The arrangement is retained

Measured corrections, with the remaining decisions clearly identified

Fuel, crossing and receiving

The decisions that stay open

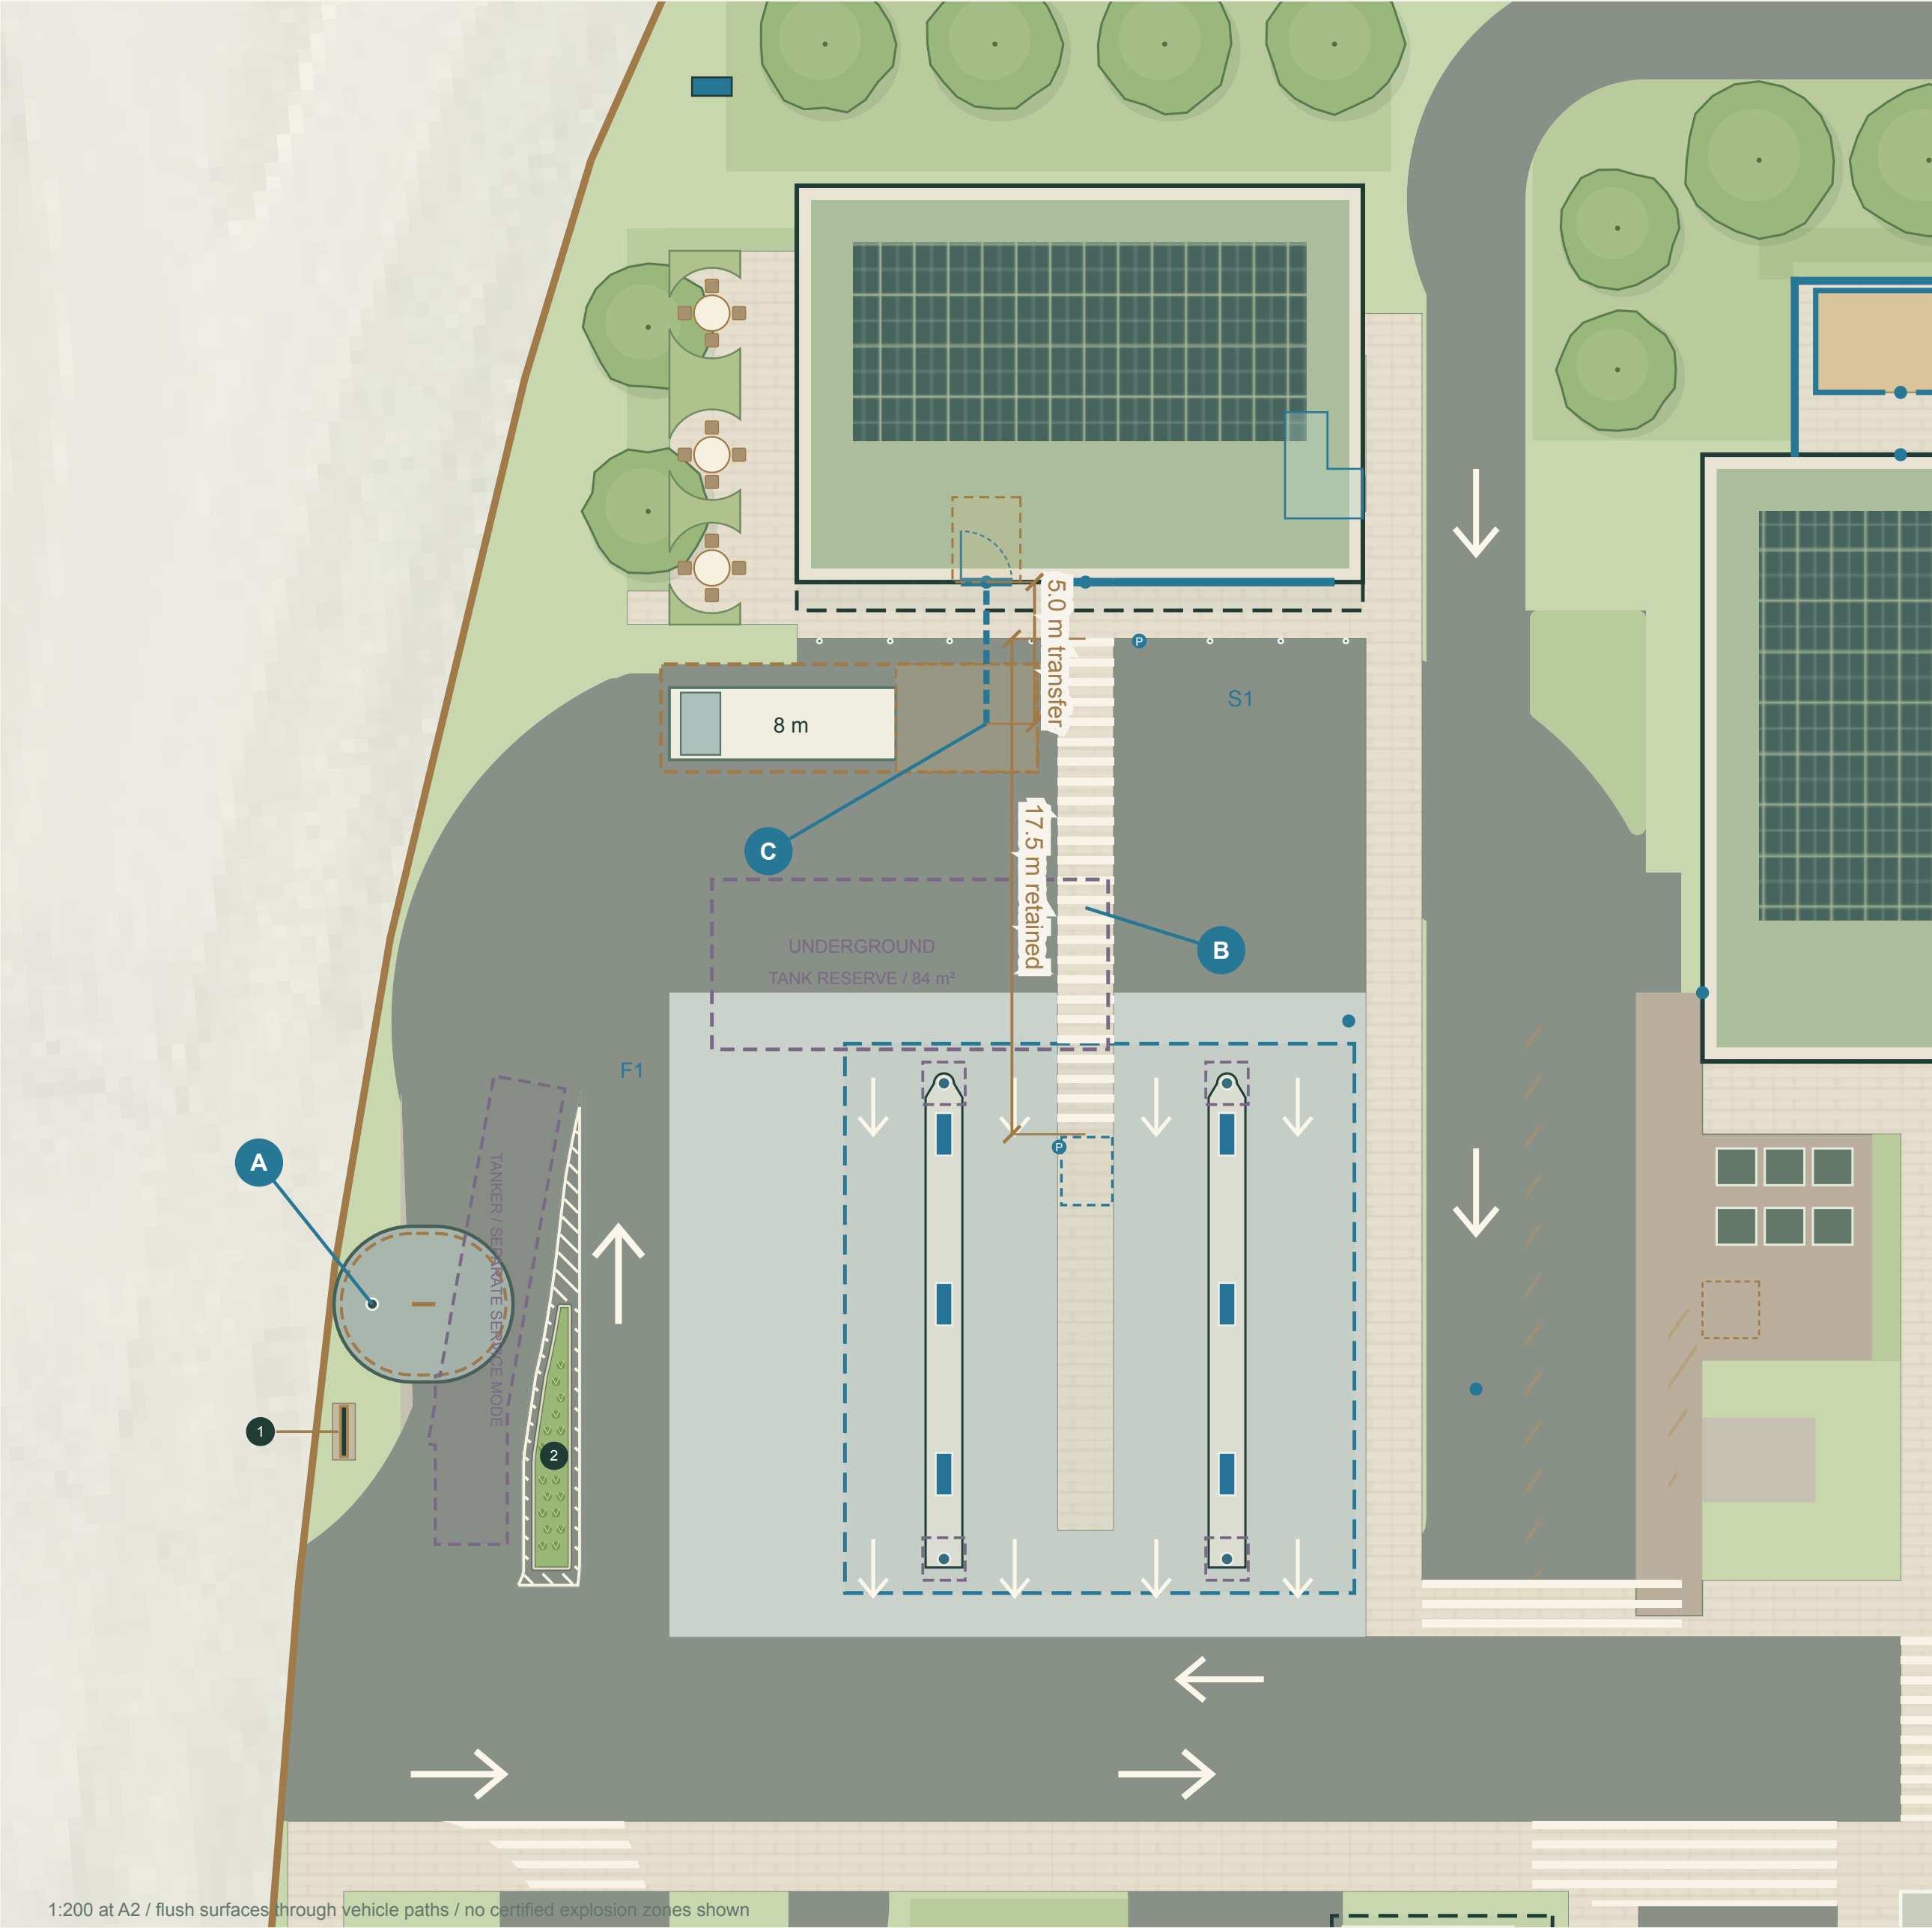
- A Contained fuel unloading**
The full inherited hose operating area now sits on a 28.26 m² fuel-resistant collection pad. No planted ground remains inside it. The fill point and tanker position stay in place.

- B An explicitly controlled crossing**
The 17.5 m crossing remains. A separate pedestrian phase holds conflicting fuel and service movements, with a clear waiting space and request points. No kerb is inserted into a vehicle sweep.

- C Short, local shop receiving**
The normal trolley trip becomes 5 m instead of 48.5 m. A timed local 8 m delivery option, inward door and working area are drawn. Larger-vehicle fallback access remains paved.

- D Greenery and seating preserved**
About 3,001 m² planted ground remains. All 218 scheduled plants, three café tables and twelve chairs retain their positions. The café edge is shaped around 1.6 m chair-use allowances and a 2 m passage.

- E Waste handling made legible**
Six bin reservations, a clear handling aisle and an inward gate fit the existing screened court. Refuse, food receiving and tanker servicing have separate booked modes.

- A Collection surface, not cosmetic paint**

The pad covers the hose operating envelope plus 0.25 m. Sealed joints, fuel-resistant construction, isolated collection and no overflow into planting are design requirements. Final falls, volume and outlet are not invented.
- 1 Tank and canopy separation**

The 84 m² tank/excavation reserve moves 1 m north. Four separate 1.5 × 1.5 m footing study boxes retain a 0.45 m minimum plan gap. Those boxes are allowances, not structural foundation sizes.
- B Protected crossing phase**

Fuel admission F1 and service movement S1 remain held until the whole crossing is clear. A 1.8 × 2.4 m waiting area stays clear of moving vehicles. Pay-at-pump is an equipment option, not a substitute for safe shop access.
- C Receiving without the long public detour**

An 8.0 × 2.55 m representative truck stands beside the shop in a booked slot. The rear work area is 5 m deep. The new 1.8 m door opens inward; one bollard moves 0.4 m to clear the transfer.
- 2 Retained public and service functions**

The main entrance, ATM inset, secure ATM room and east private staff/cash door remain. The new receiving vestibule requires coordination of the illustrative counter and internal stock route before 3D changes.
- 3 Separate service modes**

Movement and service modes

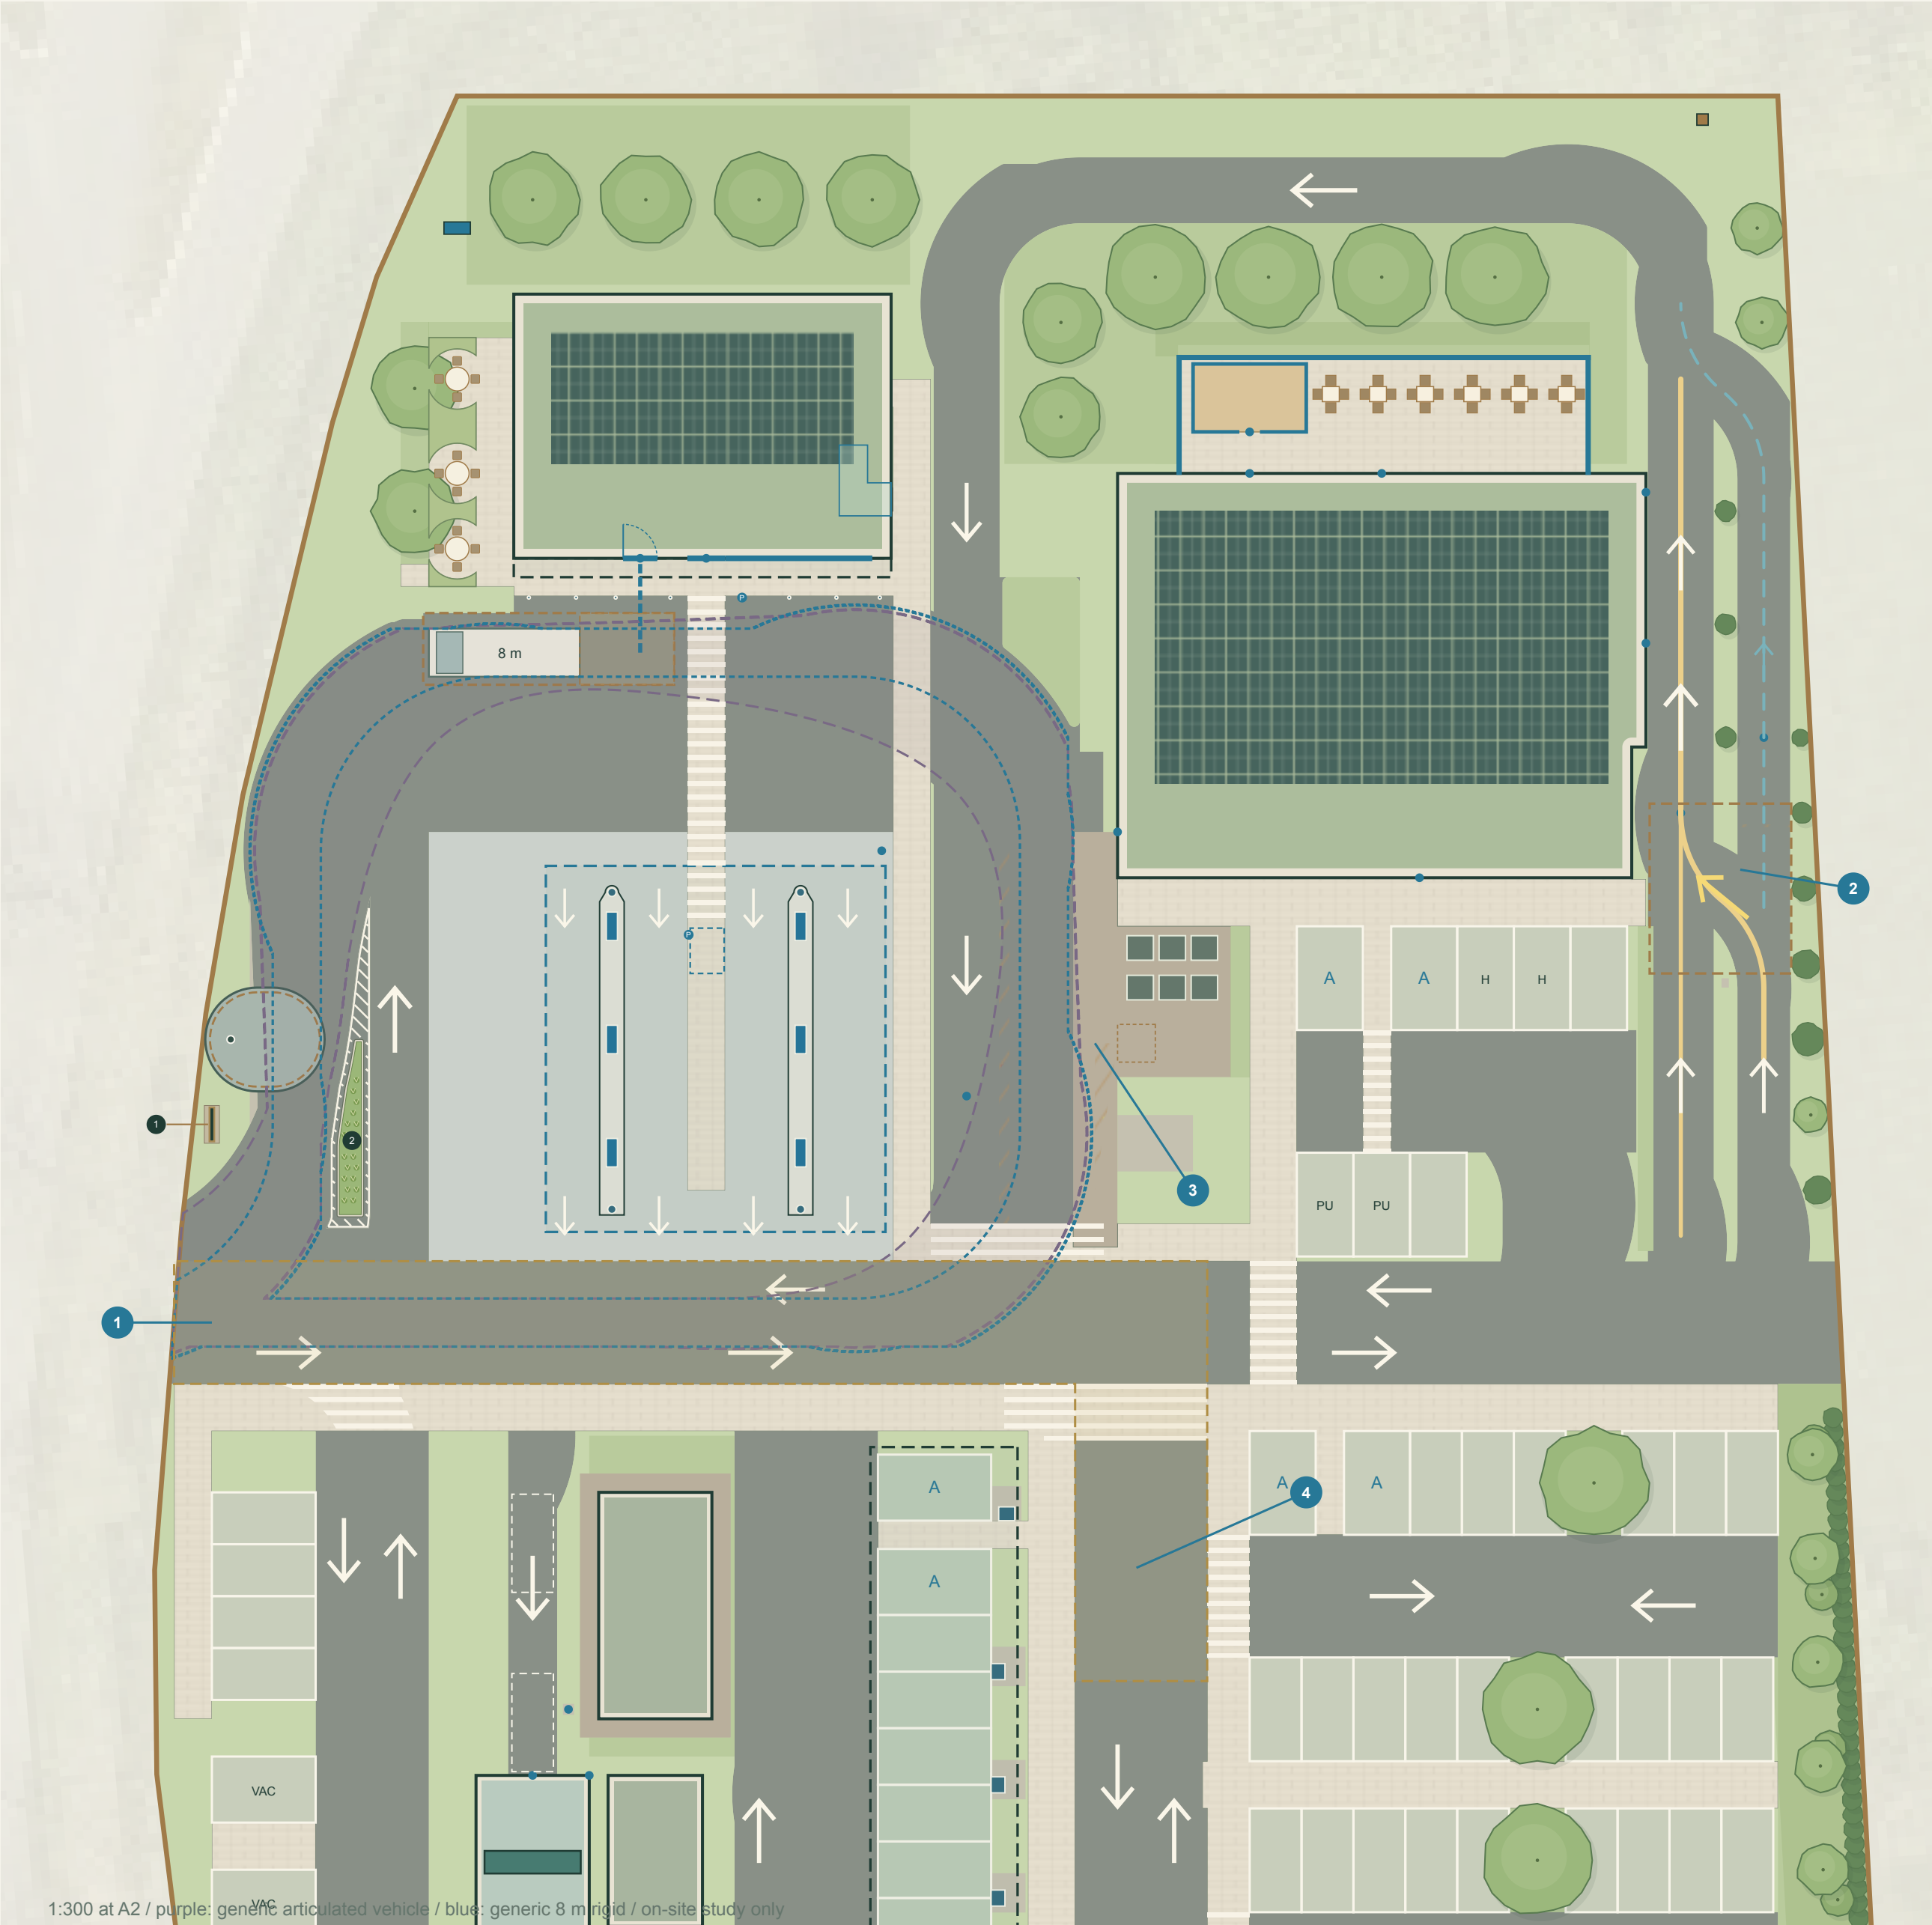
The ghost tanker and shop truck show different booked modes; they do not unload together. No new fuel arrivals during tanker movement/connected unloading in this review mode. Controls, throughput and service bookings need operator acceptance.

- 1 Actual K72 turns are still a hold**

The old straight off-site stub is no longer presented as proof of road access. Survey both road edges and levels; track selected vehicles from both directions and establish usable visibility. No highway widening is proposed on assumed land.
- 2 McDrive geometry retained**

Both orders, shared payment/collection, nine queue positions, two holding bays and the controlled escape retain their approved geometry. Release into the merge only when downstream is clear; test a failed car and occupied holding bays with McDonald's.
- 3 Service slots are mutually exclusive**

Shop receiving, tanker, refuse and grease collection do not run as independent uses of the same circulation. The normal short shop trip avoids the McDrive exit. Larger trucks still use the original shared stand and controlled transfer, subject to operator agreement.
- 4 Emergency override**

Keep the main/rear access corridor clear of deliveries, stored bins and customer queues. The existing response reserve is retained. Appliance manoeuvres, hydrant/flow, load capacity and building exits still need the fire planner and local fire service.
- 5 Checks and operating limits**

The generic 8 m rigid clears fixed objects with its 0.30 m buffer; small flush edge corrections retain 0.34 m in the drawing. These sampled geometry checks do not certify supplier steering, public-road turns or operating capacity.
